April 11, 2014

Re: Connecticut Siting Council Docket No. 436
Certificate Holder Message Center Management, Inc. (MCM)
Telecommunications Facility in East Hartford, Connecticut

1. Revised Development and Management Plan Sheet A1 prepared by All Points Technology Corporation dated September 12, 2012 and last revised April 10, 2014;

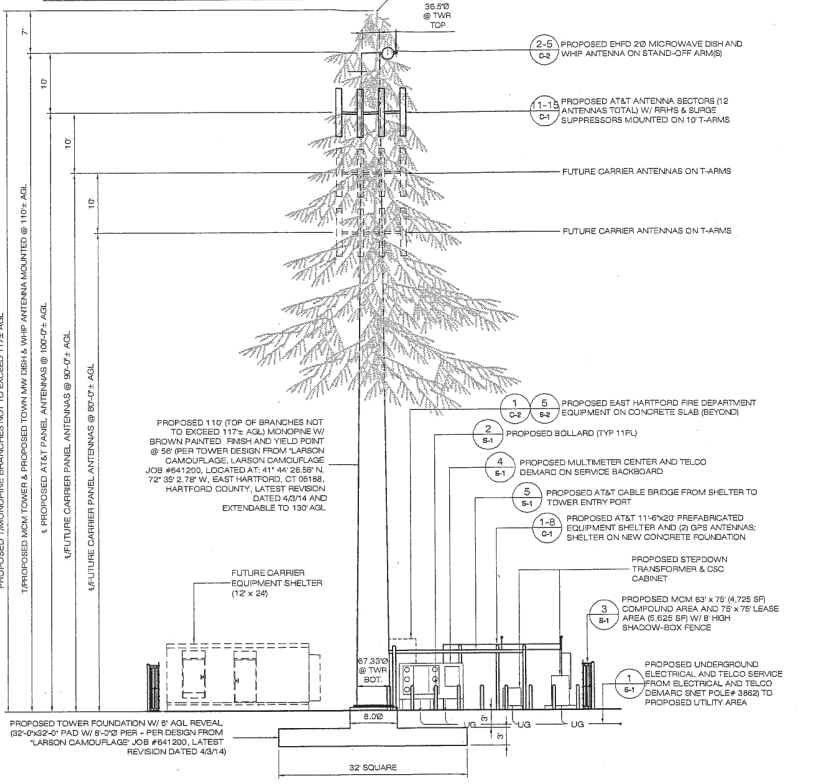
MCM is currently finalizing its order for the approved tower which includes camouflage branching in accordance with Condition One of the Siting Council's Decision and Order and approved Development and Management Plan in Docket 436. The specifications provided in the final/pending order with MCM's tower vendor included more camouflage branching than depicted in the materials previously provided to MCM and submitted to and approved by the Siting Council in its review of the Development and Management Plan. As more branching will only serve to better camouflage the Facility, MCM plans to proceed with that order. However, analysis of the tower loading with this additional branching indicates a need for an expansion of the tower foundation from the 27' x 27' (as per the September 17, 2013 D&M submission on file with the Siting Council) to a new dimension of 32' x 32' (as per the revised Sheet A1 attached).

An enlargement of the foundation and the associated branching are the only deviations from the approved Development and Management Plan. No changes or modifications to the approved tower location, equipment, compound, fencing, access drive or other features of the approved Facility are proposed. While we do not believe this enlarged foundation is a change of any significance to the approved Facility, we submit this letter and enclosures by way of update and notification to the Siting Council in keeping with R.C.S.A. Sec. 16-50j-77(2). Given the minor nature of this change we respectfully request a staff approved amendment to the D&M Plan for the Facility.
